Geology and Soils Evaluation Report

Subdivision
er Road

El Paso County, Colorado

VIVID Project No.: D24-2-807

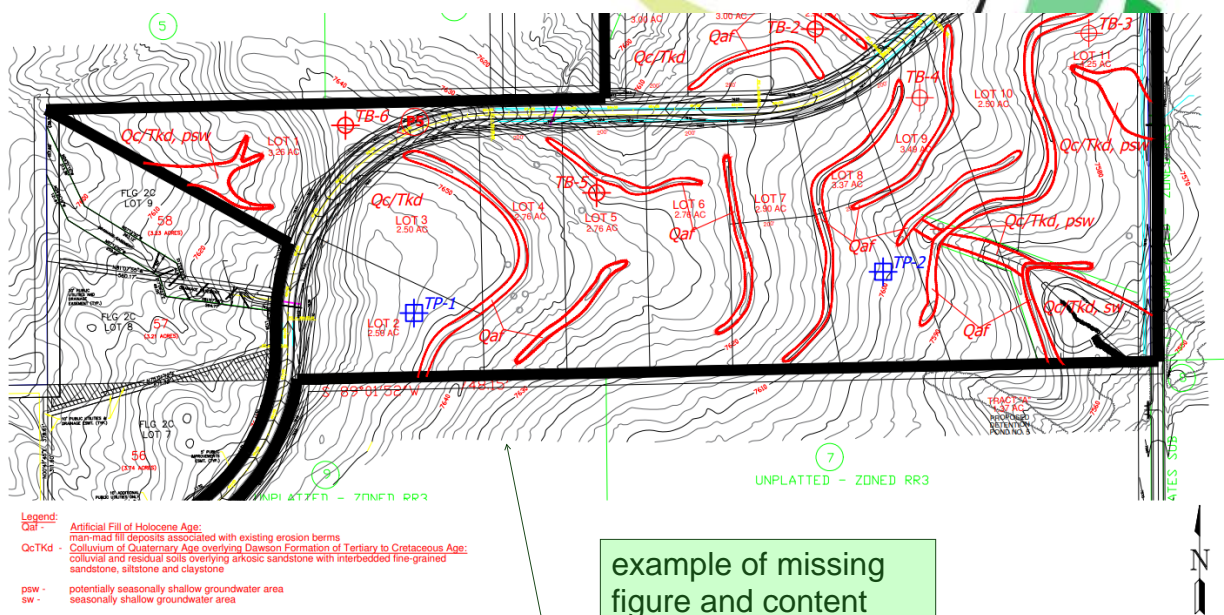
See 8.4.9 of the Code...The report should identify constraints and hazards. Drainages are constraints that do not appear to be identified. Groundwater Potential should be identified for the lots and mapped.

example of missing figure and content
see link for example of a report meeting Code
